FED. ROAD DIST. NO.	STATE	FED. AID PROJ. NO.	FISCAL YEAR	SHEET NO.	TOTAL SHEETS
HAWAII	HAW.	HSIP-019-1(41)	2018	ADD.19	43

12/1/17	Replace original Sheet No. 20
DATE	REVISION
STATE OF HAWAII DEPARTMENT OF TRANSPORTATION HIGHWAYS DIVISION DRAINAGE DETAILS QUEEN KAAHUMANU HIGHWAY INTERSECTION IMPROVEMENTS at KAWAIHAE ROAD Federal Aid Project No. HSIP-019-1(41) Scale: 1/4"=1'-0" Date: Sept., 2017 SHEET No. H2 OF 2 SHEETS

DETAILS OF GRP INLET STRUCTURE AT Sta. 9+42± O/S 53'± LT.

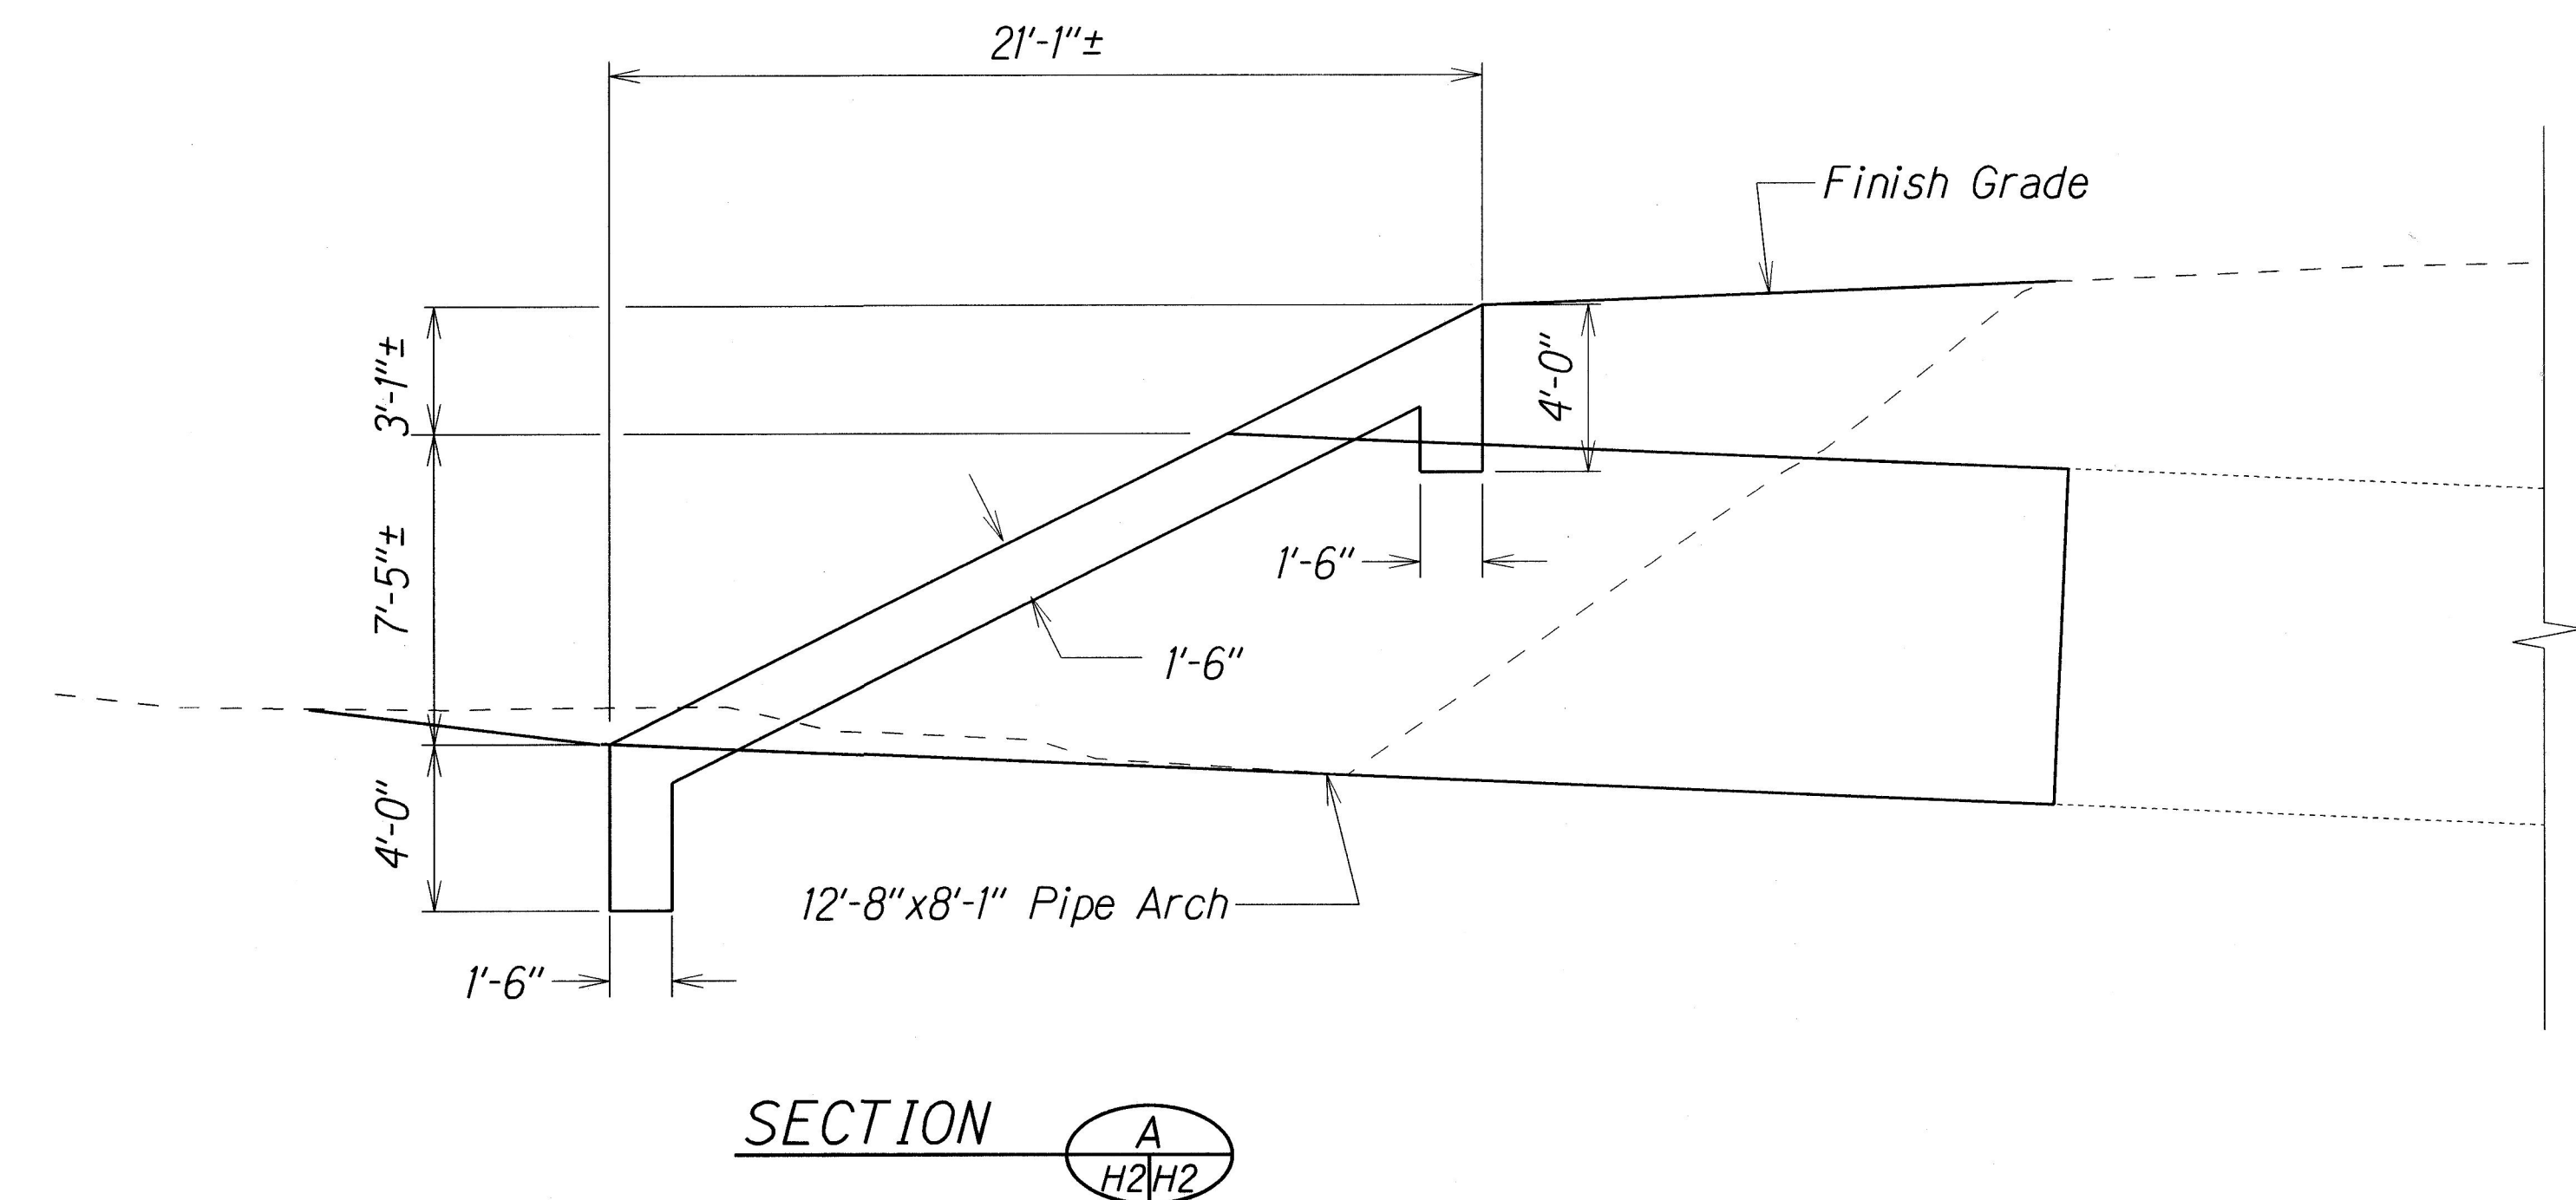
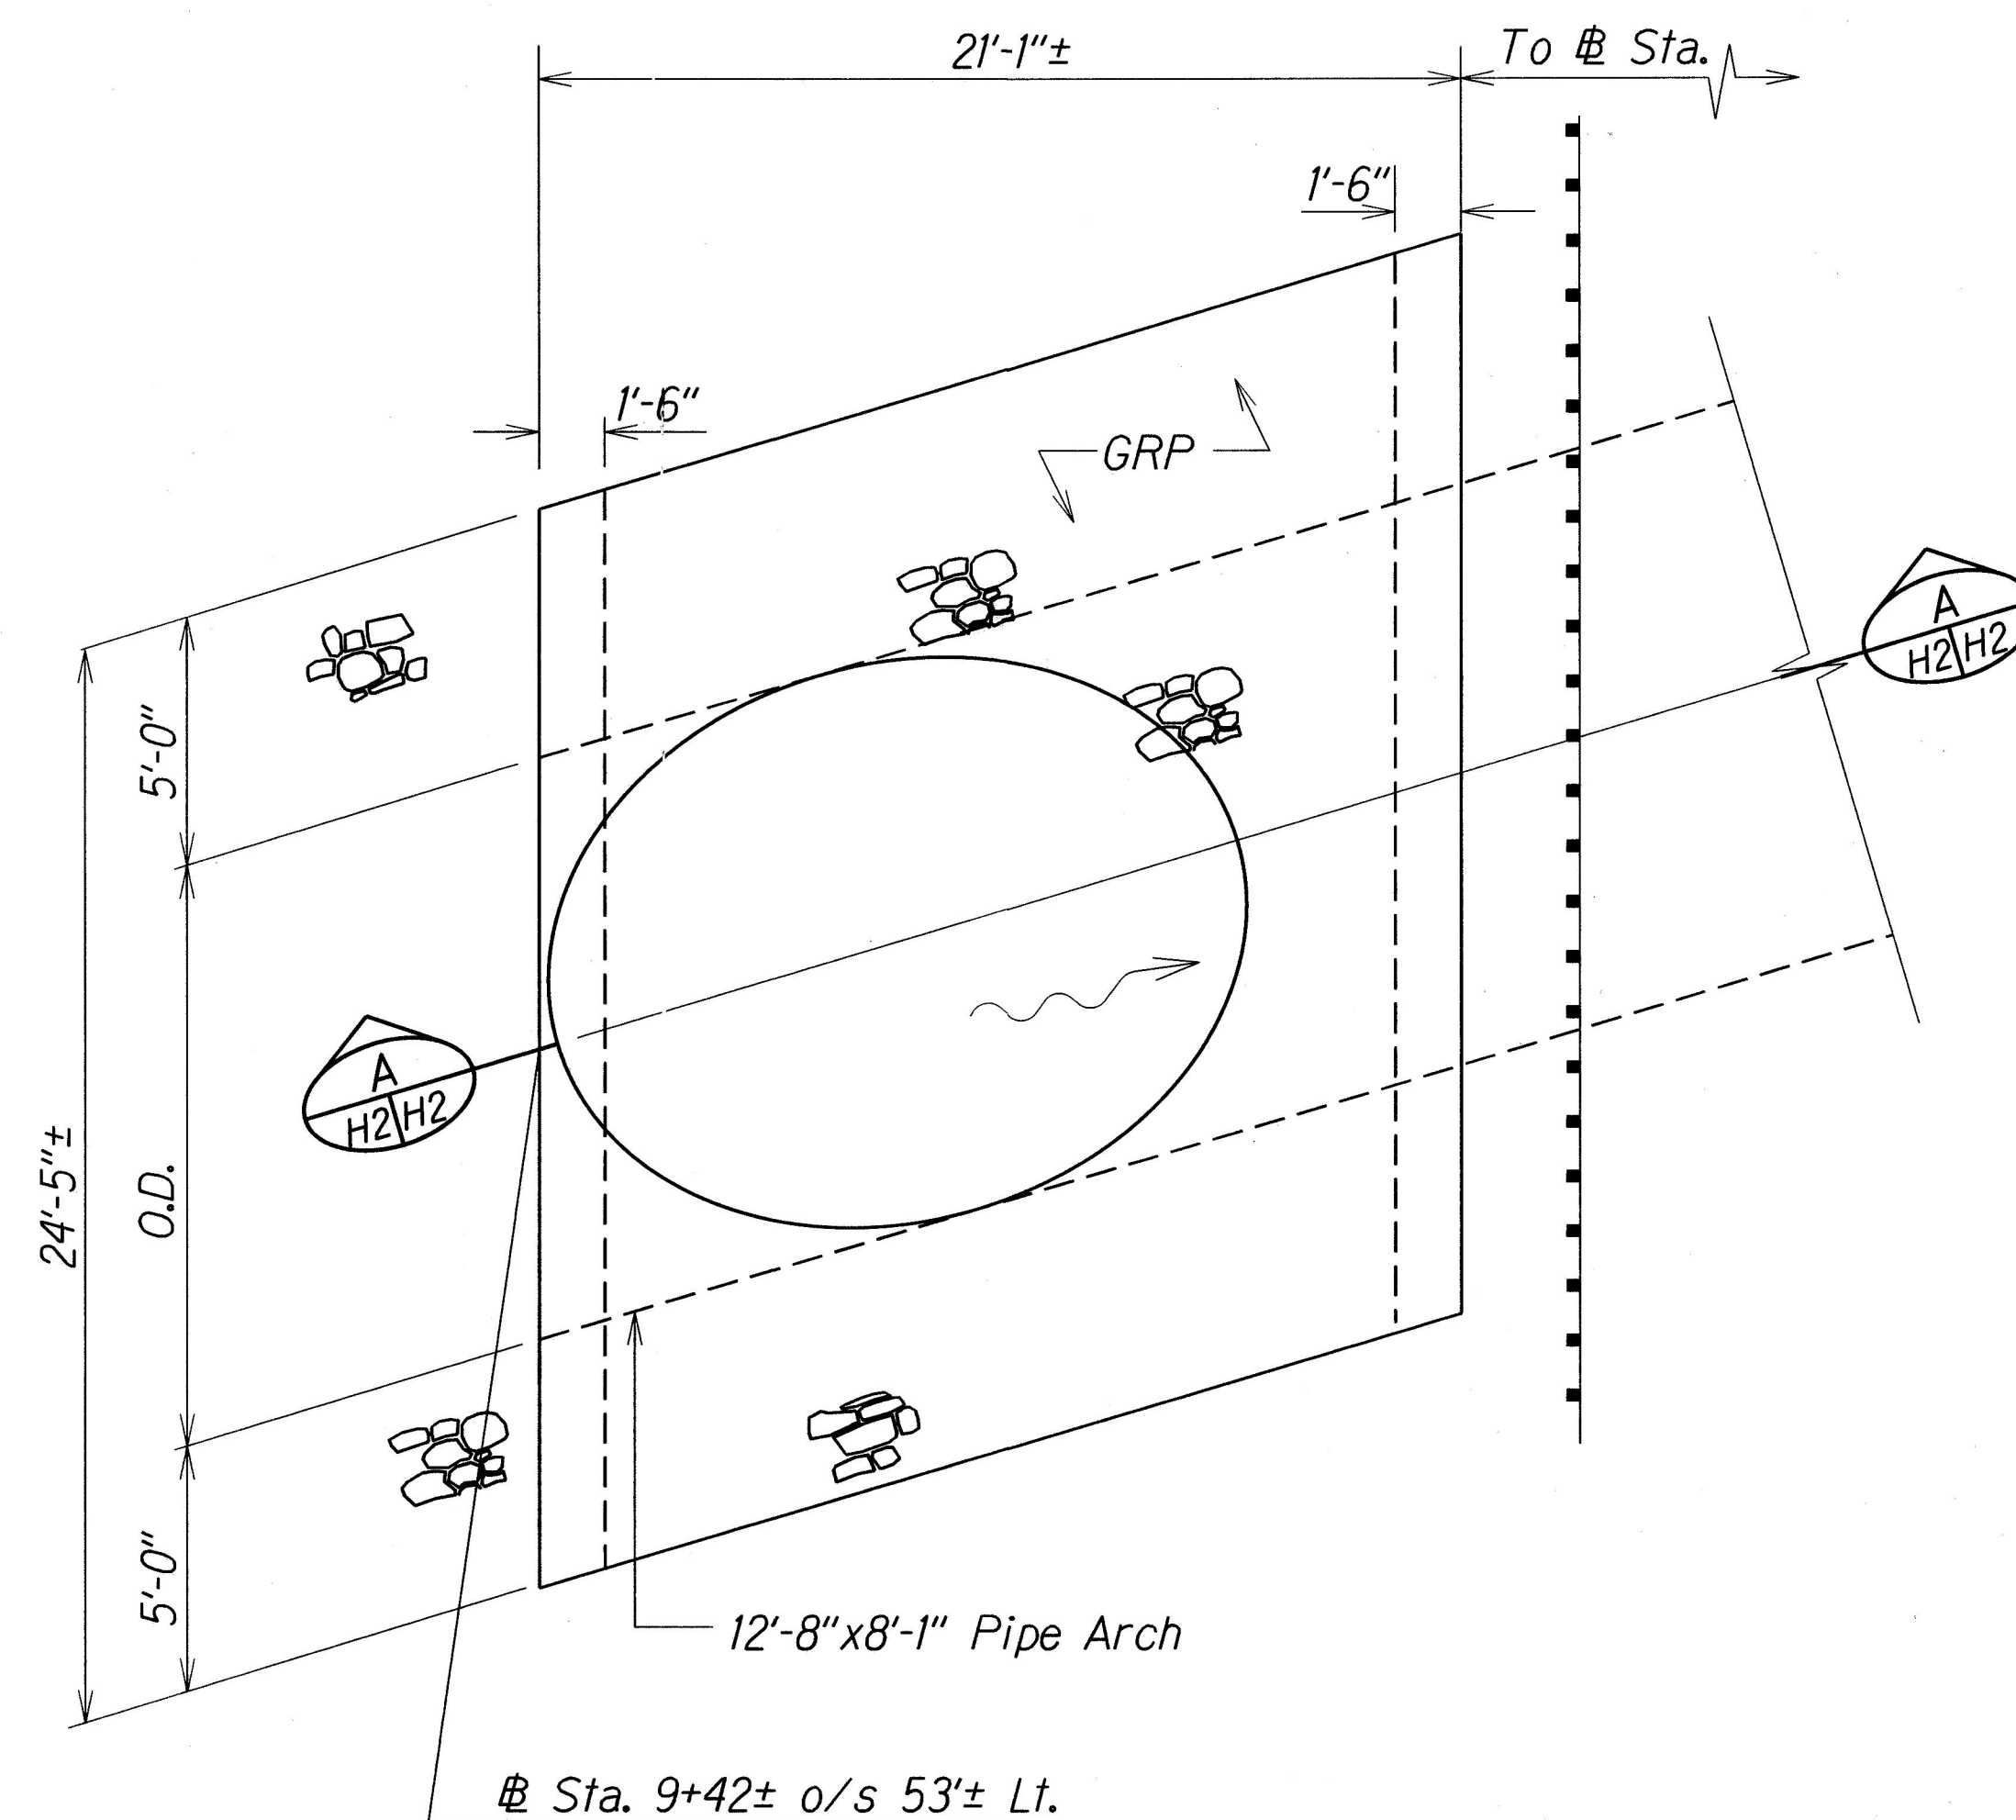
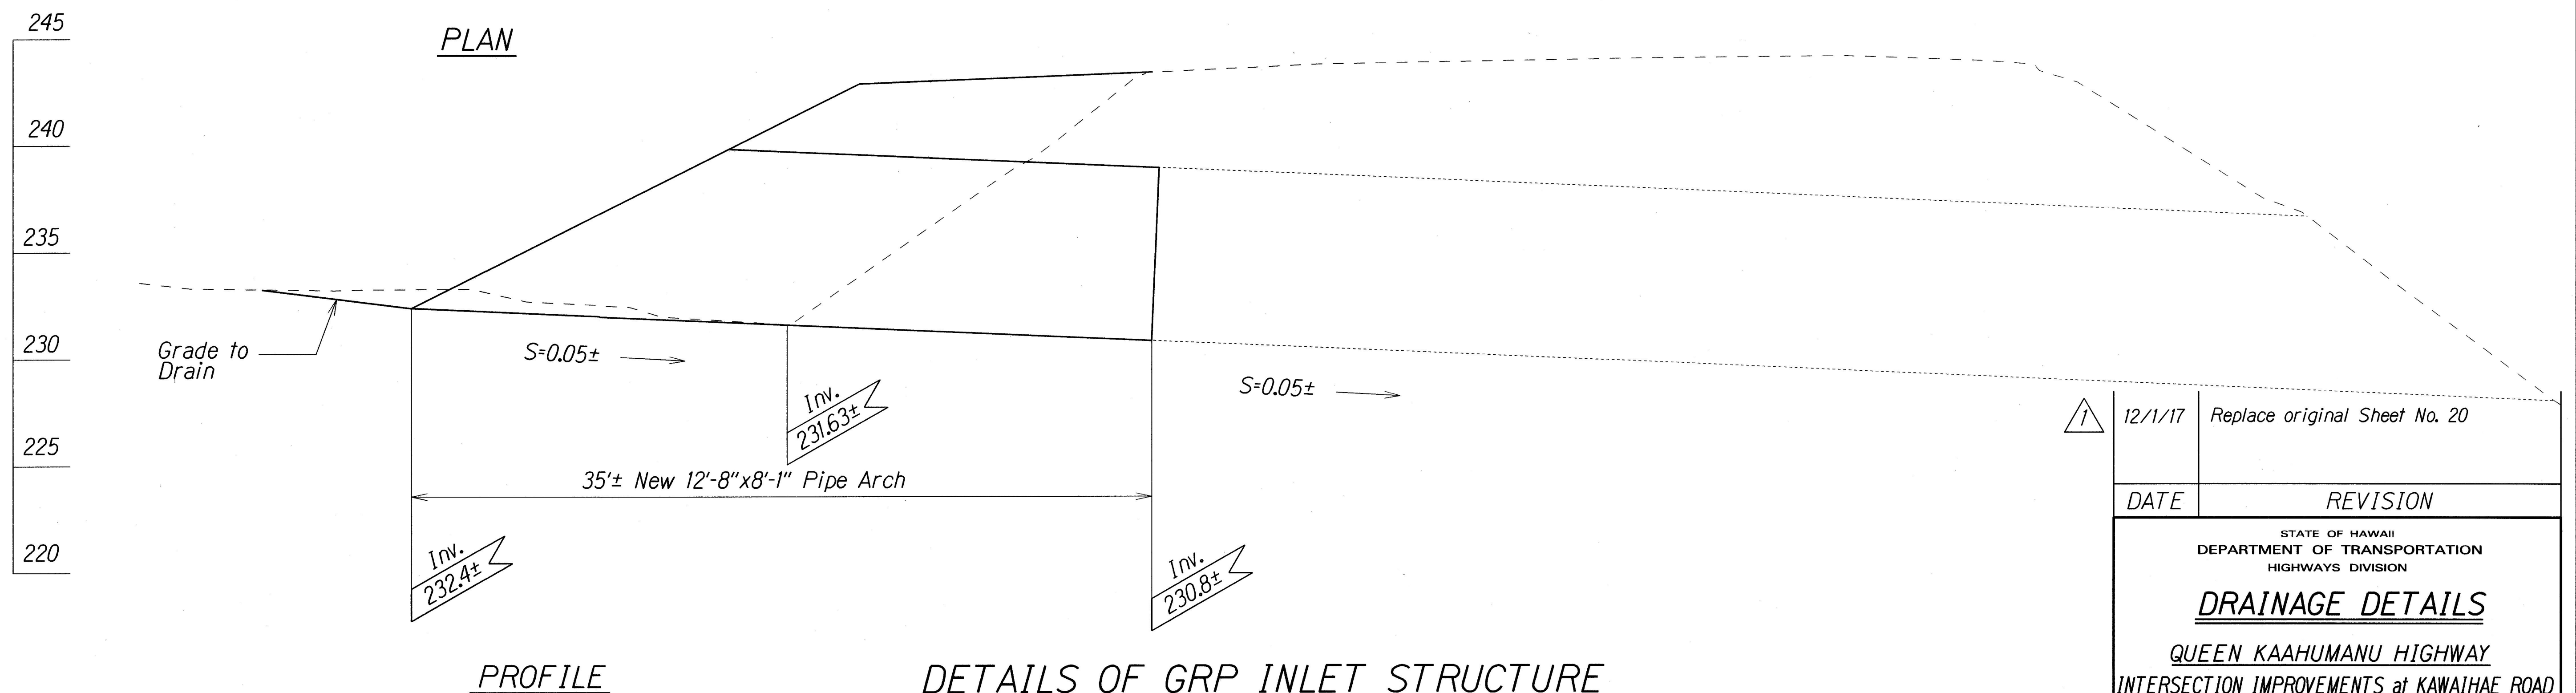
Demolish, Remove, and Dispose approximately 17 L.F. of existing culvert. Remove at existing seams. Excavate as necessary to reinstall new sections of culvert.
